Subject: Request for Amendment to Technical
Specification 3/4.3.2, "Isolation
Actuation Instrumentation"

DISCUSSION AND JUSTIFICATION FOR THE PROPOSED CHANGES

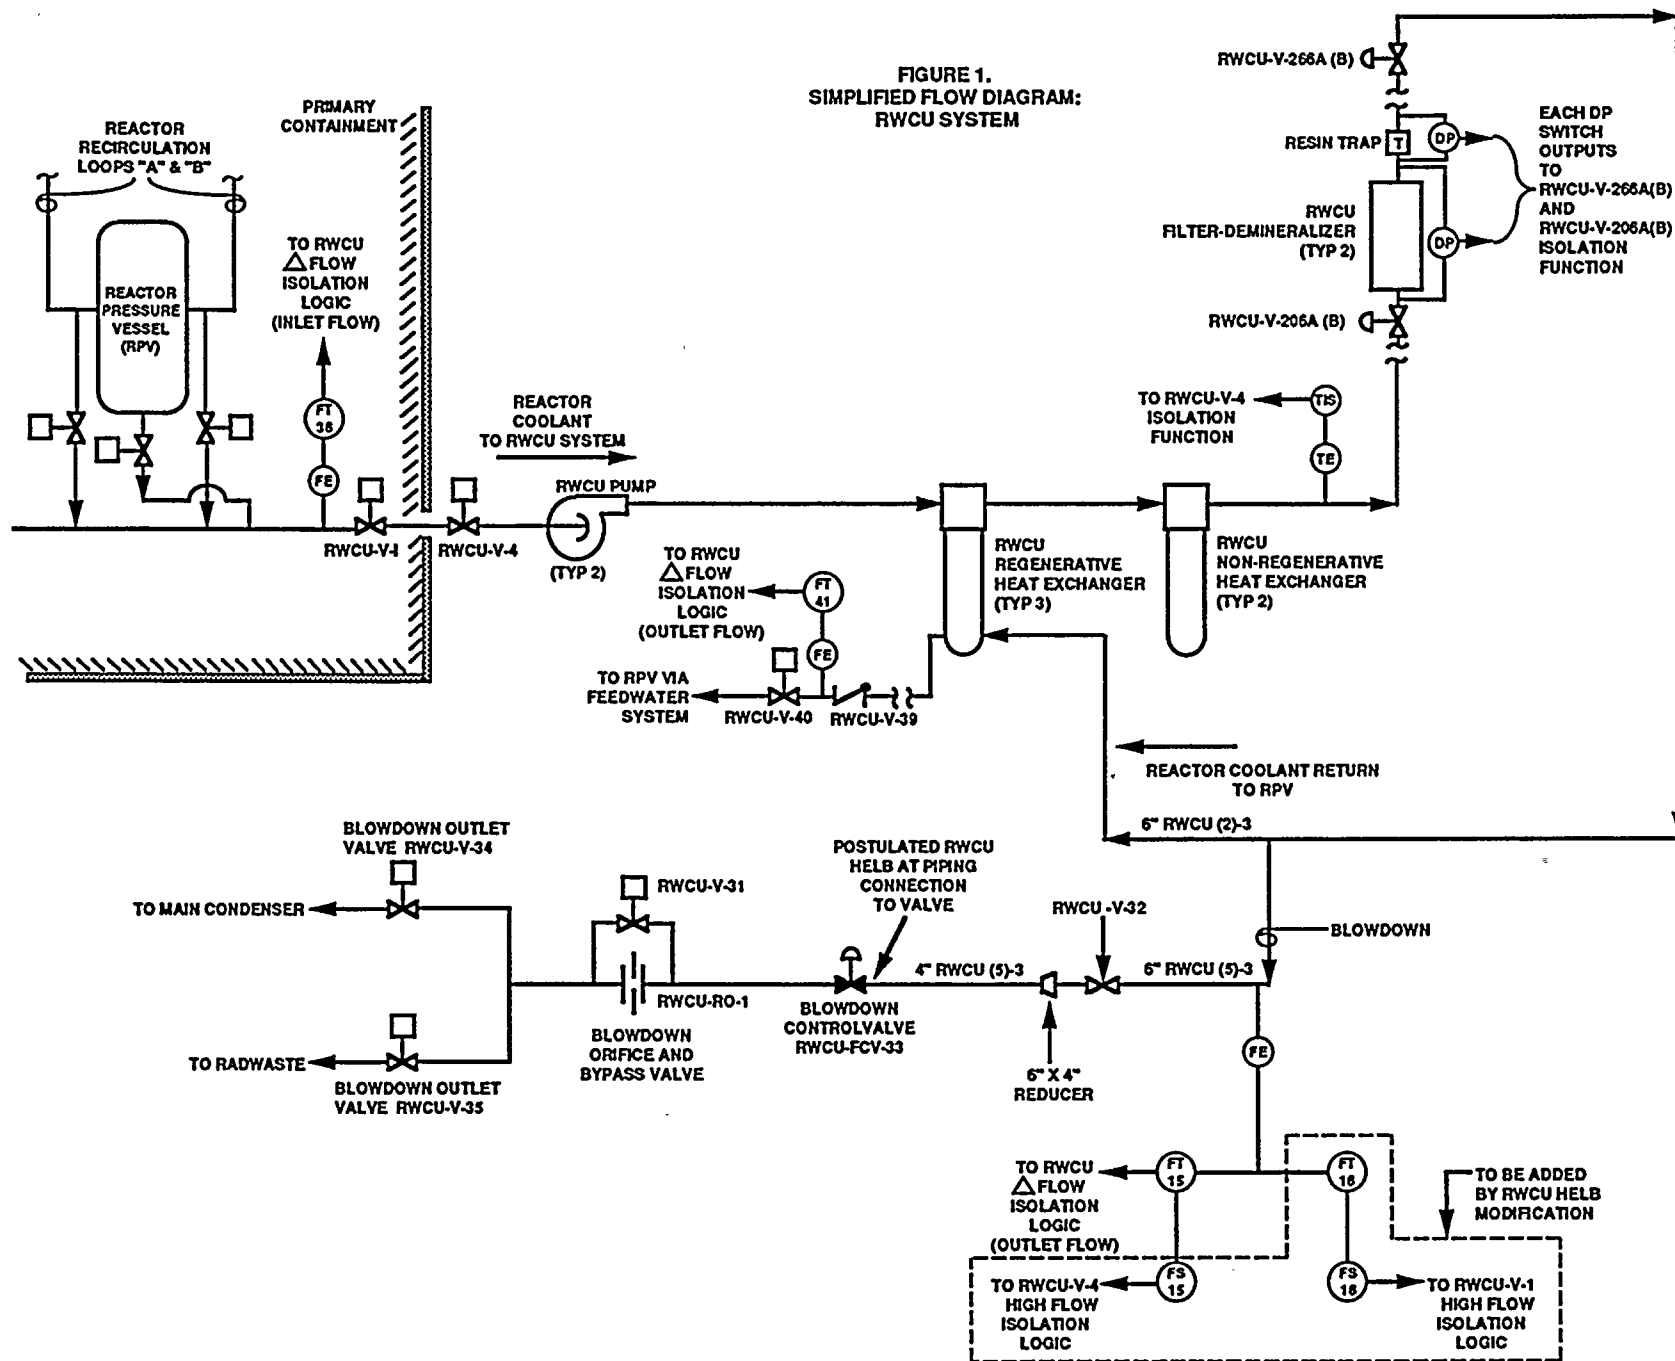
The RWCU system continuously purifies reactor coolant water during all modes of reactor operation and is described in WNP-2 Final Safety Analysis Report (FSAR), Subsection 5.4.8. Figure 1, "Simplified Flow Diagram: RWCU System," is enclosed for reference and information. The system takes suction from the inlet of each Reactor Recirculation (RRC) system pump and from the reactor pressure vessel (RPV) bottom head. Processed water is returned to the RPV via the Reactor Feedwater (RFW) system and/or the main condenser or the Radwaste system. The portion of the system located within the primary containment and the small portion located outside of containment up to and including the outboard containment isolation valve are considered part of the reactor coolant pressure boundary (RCPB). The other portions of the system are not part of the RCPB and, in the event of detected reactor coolant leakage, are automatically isolated by closure of an A.C. (inboard) and D.C. (outboard) motor-operated containment isolation valve (RWCU-V-1 and RWCU-V-4). The majority of the RWCU system equipment is located in the Reactor Building and include two RWCU pumps and three regenerative and two nonregenerative heat exchangers. The two filter-demineralizers and supporting equipment are located in the Radwaste Building.

The Supply System proposes to amend Technical Specification 3/4.3.2, "Isolation Actuation Instrumentation" to add the new RWCU "Blowdown Flow - High" trip function to Tables 3.3.2-1, 3.3.2-2, and 4.3.2.1-1. This proposed amendment incorporates the design features being implemented to reduce the detection and isolation time for the postulated RWCU HELB.

Add "Blowdown Flow - High" as Trip Function 3.k. The valve group signal, required number of operable channels, and applicable operational conditions are to be the same as the existing RWCU "Δ Flow - High" trip function (3.a) requirements. Also add "Action 27" to "Close valve RWCU-V-32 within 1 hour or perform Action 22."

Add "Blowdown Flow - High" as Trip Function 3.k. Also add the associated trip setpoint of ≤ 264.5 gpm and an allowable value of ≤ 271.7 gpm.

Add "Blowdown Flow - High" as Trip Function 3.k. The channel check, channel functional test, and channel calibration surveillance intervals, and applicable operational conditions are to be the same as the existing RWCU "Δ Flow - High" trip function (3.a) requirements.
